UNITED STATES
DEPARTMENT OF THE INTERIOR
BUREAU OF LAND MANAGEMENTNM OIL CONSERVATION
ARTESIA DISTRICT
JUL 25 2014
ArtesiaFORM APPROVED
OMB NO. 1004-0135
Expires: July 31, 2010**SUNDRY NOTICES AND REPORTS ON WELLS**
Do not use this form for proposals to drill or to re-enter an abandoned well. Use form 3160-3 (APD) for such proposals.

1. Type of Well <input checked="" type="checkbox"/> Oil Well <input type="checkbox"/> Gas Well <input type="checkbox"/> Other		5. Lease Serial No. NMLC061862
2. Name of Operator DEVON ENERGY PRODUCTION CO LP		6. If Indian, Allottee or Tribe Name
Contact: TRINA C COUCH Email: trina.couch@dvn.com		7. If Unit or CA/Agreement, Name and/or No.
3a. Address 333 WEST SHERIDAN AVE OKLAHOMA CITY, OK 73102	3b. Phone No. (include area code) Ph: 405-228-7203	8. Well Name and No. COTTON DRAW 14 FED COM 1H
4. Location of Well (Footage, Sec., T., R., M., or Survey Description) Sec 14 T25S R31E NWNW 0330FNL 1150FWL 32.136755 N Lat, 103.753498 W Lon		9. API Well No. 30-015-42091-00-X1
		10. Field and Pool, or Exploratory PADUCA
		11. County or Parish, and State EDDY COUNTY, NM

Cotton Draw 14 FED COM 1H- APD DRILLING PLAN
JSP 11.5.13

OPERATOR'S NAME:	Devon Energy Prod

DRAWING NUMBER
DM100161771-2B

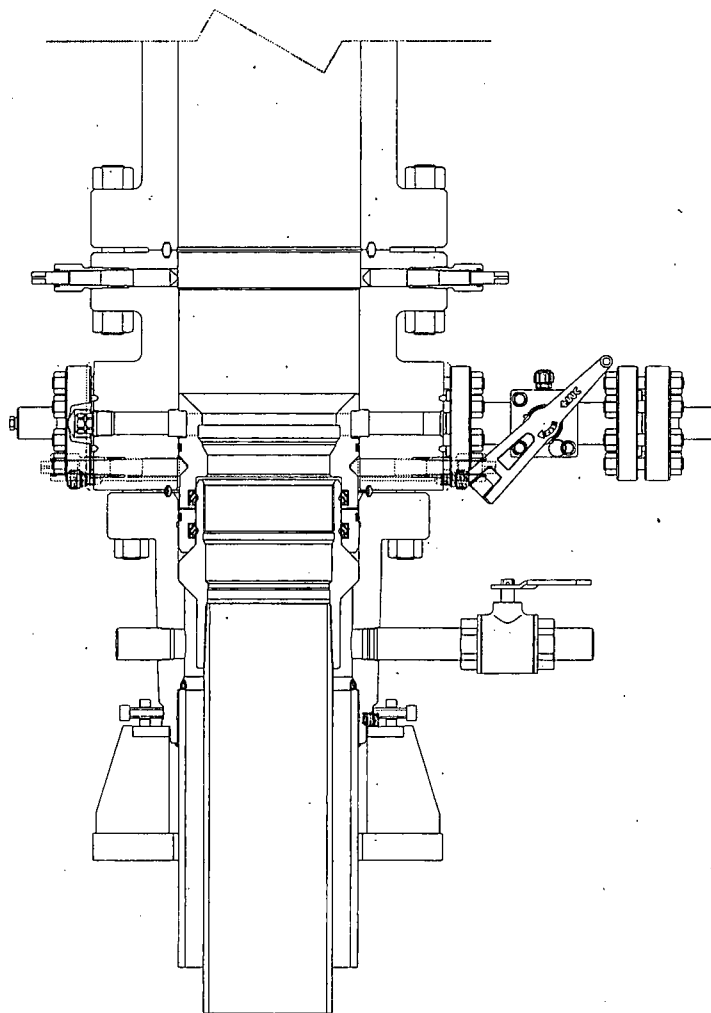
* FMC will install a solid steel body pack-off to completely isolate the lower head after cementing intermediate casing. After installation of the pack-off, the pack-off and the lower flange will be tested to 5M, as shown on the attached schematic. Everything above the pack-off will not have been altered whatsoever from the initial nipple up. Therefore the BOP components will not be retested at

* Devon will pressure test all seals above and below the mandrel (but still above the casing) to full working pressure rating.

* Devon will test the casing to 70% of burst or 1500 psi, whichever is greater, as per Onshore Order #2.

After running the 13 3/8" surface casing, a 13 5/8" BOP/BOPE system with a minimum rating of 5M will be installed on the FMC Uni-head wellhead system and will undergo a 250 psi low pressure test followed by a 5,000 psi high pressure test. The 5,000 psi high and 250 psi low test will cover testing requirements a maximum of 30 days, as per Onshore Order #2. If the well is not complete within 30 days of this BOP test, another full BOP test will be conducted, as per Onshore Order #2.

After running the 9 5/8" intermediate casing with a mandrel hanger, the 13 5/8" BOP/BOPE system with a minimum rating of 5M will already be installed on the FMC Uni-head. Please find attached the wellhead schematic and drilling plan.

- 1. Operator has proposed a multi-bowl wellhead assembly. This assembly will only be tested when installed on the surface casing. Minimum working pressure of the blowout preventer (BOP) and related equipment (BOPE) required for drilling below the surface casing shoe shall be 5000 (5M) psi.**

- a. Wellhead shall be installed by manufacturer's representatives, submit documentation with subsequent sundry.**
 - b. If the welding is performed by a third party, the manufacturer's representative shall monitor the temperature to verify that it does not exceed the maximum temperature of the seal.**

- c. Manufacturer representative shall install the test plug for the initial BOP test.**
 - d. Operator shall perform the intermediate casing integrity test to 70% of the casing burst. This will test the multi-bowl seals.**

- e. If the cement does not circulate and one inch operations would have been possible with a standard wellhead, the well head shall be cut off, cementing operations performed and another wellhead installed.**

5M system requires an HCR valve, remote kill line and annular to match. The remote kill line is to be installed prior to testing the system and tested to stack pressure.
